**DOMINION VIRGINIA POWER**  
**NORTH ANNA UNIT 3 COMBINED LICENSE APPLICATION**  
**RESPONSE TO REQUEST FOR ADDITIONAL INFORMATION LETTER NO. 002**

**Response to NRC RAI Letter No. 002**

**RAI Question 02.03.02-1**

**Table 1.9-204 Industrial Codes and Standards**

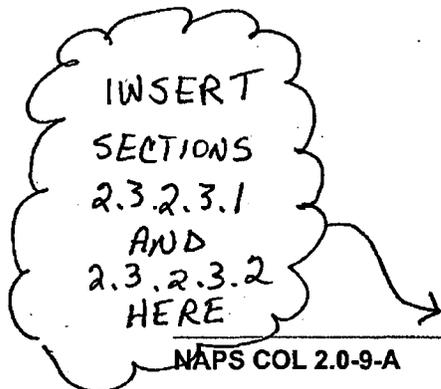
Add >

C57.19.100 -  
1995 (R2003)

IEEE Guide For Application of Power Apparatus Bushings

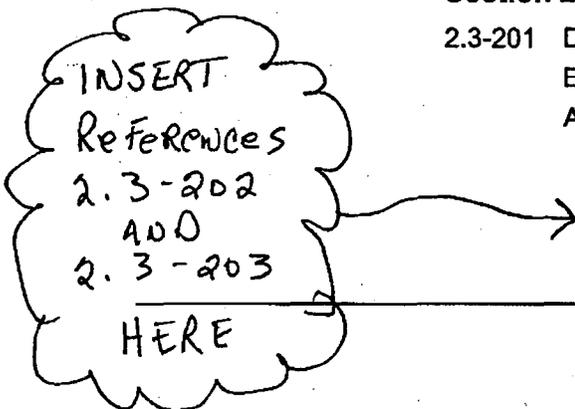
The fifth paragraph of this SSAR section is supplemented as follows with information to address the receptors near the Unit 3 site.
